**Re: Newcastle Gas Storage Facility ISBL – Peer Review Services
Summary Report to Period Ending 8 October 2013**

RE: AGL Energy Limited Newcastle Gas Storage Facility – Storm Water Management Peer Review Part 1: Design Modelling

Newcastle Gas Storage Facility Site Design Review for Surface Water Management Systems

Figure 1 – MUSIC Schematic (WorleyParsons, 2010)

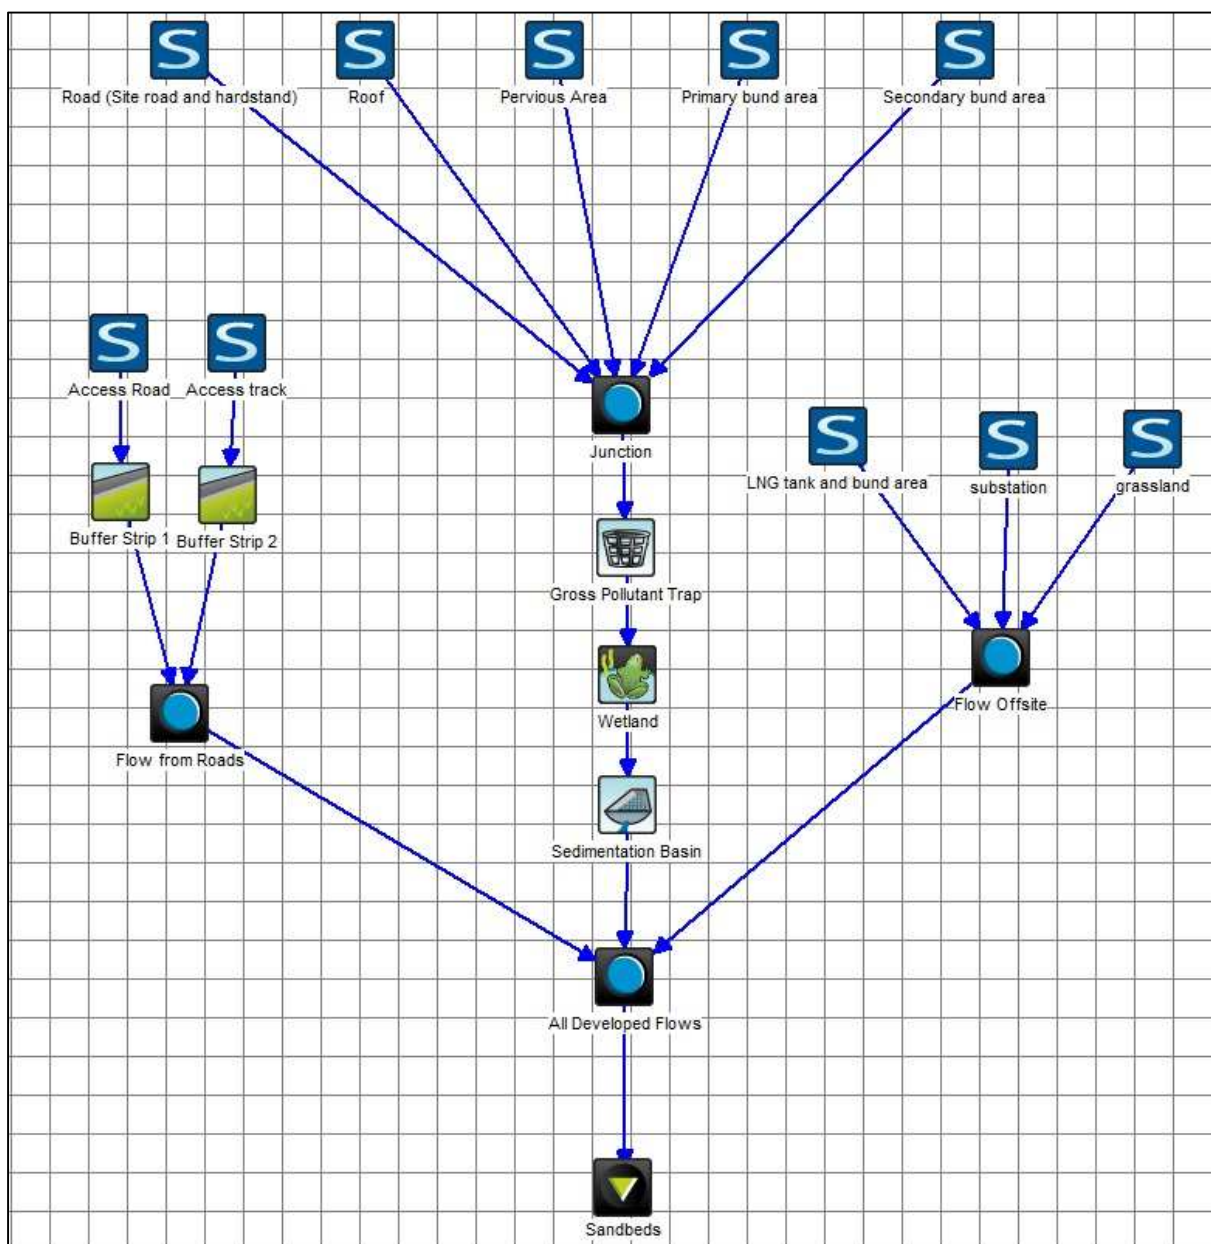
It may be noted in **Figure 1** that the receiving waters are labelled as “Sandbeds.” This node has no properties other than the purpose of outputting results. As such, this is simply a graphical error that has not been modified along with the design changes and does not affect the previous model results.

Basic data such as catchment areas and the ratios of impervious to pervious areas have been reviewed in the model and found to be consistent with the plans in **Attachment A**. The parameters for all nodes have been reviewed against the appropriate guidelines and notable differences are presented in **Table 1**. A detailed review of parameters and guidelines can be found in **Attachment B**.

Figure 2 –Comparison of DRAINS and Water Balance Modelling Results

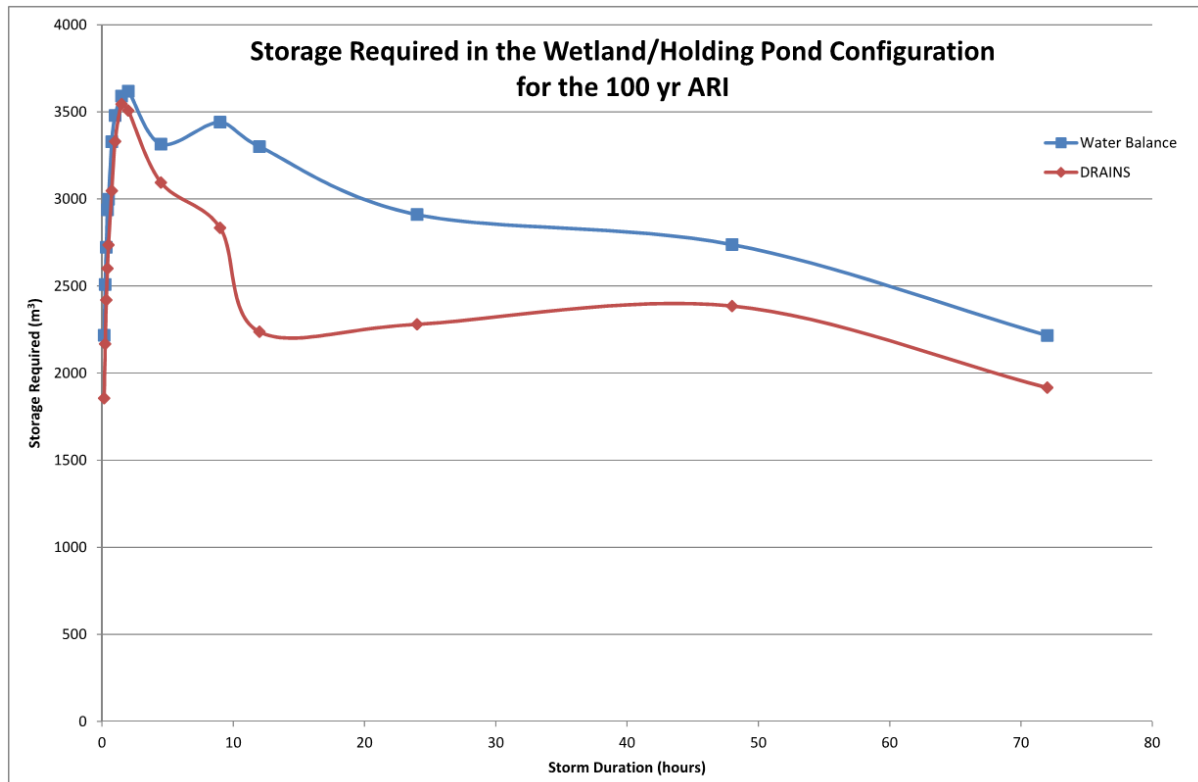
Figure 2 compares the results of the Water Balance and the DRAINS model for the 100 year ARI for a range of storm durations. The peak storage calculated in the model is 3544m³, which contains the 1.5 hour duration storm. Comparatively, the peak storage calculated in the Water Balance model is 3619m³, which contains the 2 hour storm duration.

Figure 2 displays a reduction in storage required with the increase of storm durations. This is due to the pump outflow of the storage system, which can withdraw larger volumes over a longer duration. The Water Balance results show a slower decay in storage required, as continuing losses in the model are fixed and are conservative. The DRAINS model assumes a non-linear rate of groundwater infiltration as it accounts for the rate of soil moisture uptake as a function of the soil moisture storage.

The difference in peak storage results between the models are considered negligible as they are in the order of 2-3%, verifying that the DRAINS modelling is sufficient for assessing the storage required for the storm water management plan.

A more conservative approach, such as the water balance model, may be beneficial as it may be noted in **Figure 2** the change in volume of the longer duration storms is significant between the two models. The models assume that pumping occurs at the full capacity of design. If this is not the case and some pump efficiency is lost, the maximum storage required could easily be governed by a longer duration storm such as the 12hr event in the water balance model. It is recommended that WorleyParsons adopt a conservative approach similar to SMEC and simulate some lower pump efficiency scenarios to account for this.

General photo showing installed slab reinforcement and waterstop

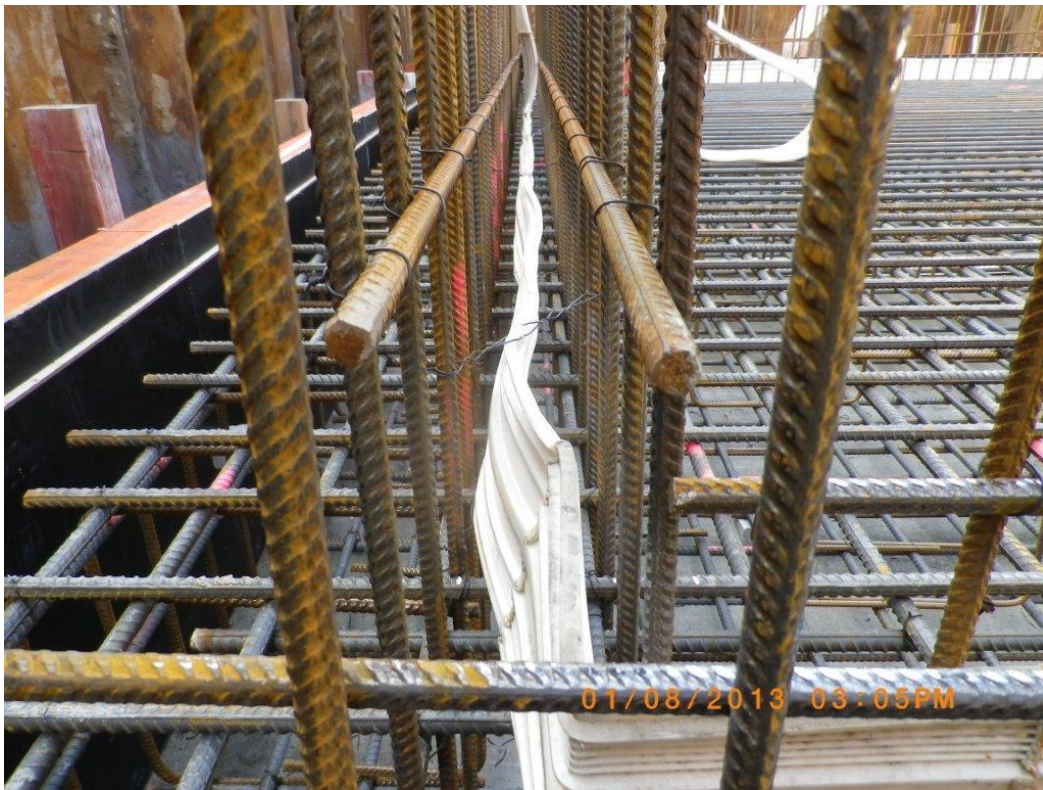
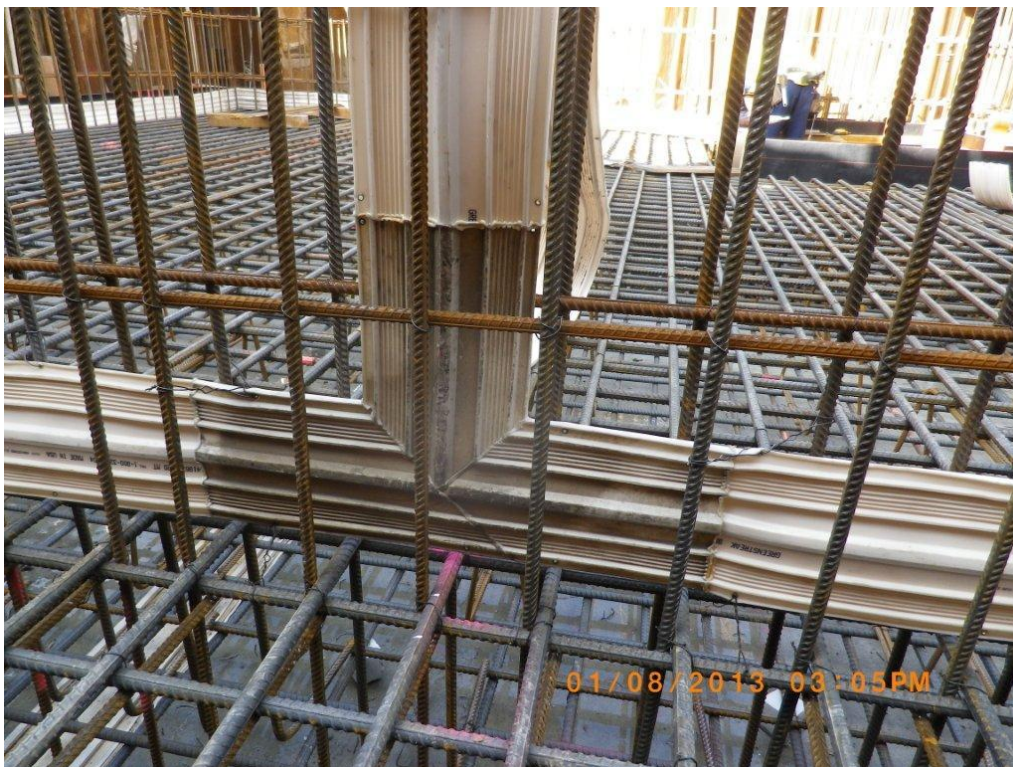
2. Construction appeared to be of a standard that would allow the works to comply with the Approved Storm Water Management Philosophy. In particular SMEC noted water stops placed in position in accordance with the design drawings (refer to photos attached).

4. SMEC is satisfied with the standard of the works subject to the following:
 - a. Approval shall first be obtained from a qualified Structural Engineer prior to placement of concrete;

- b. Attention is paid to saw cuts to ensure they do not cut reinforcement and are sealed correctly
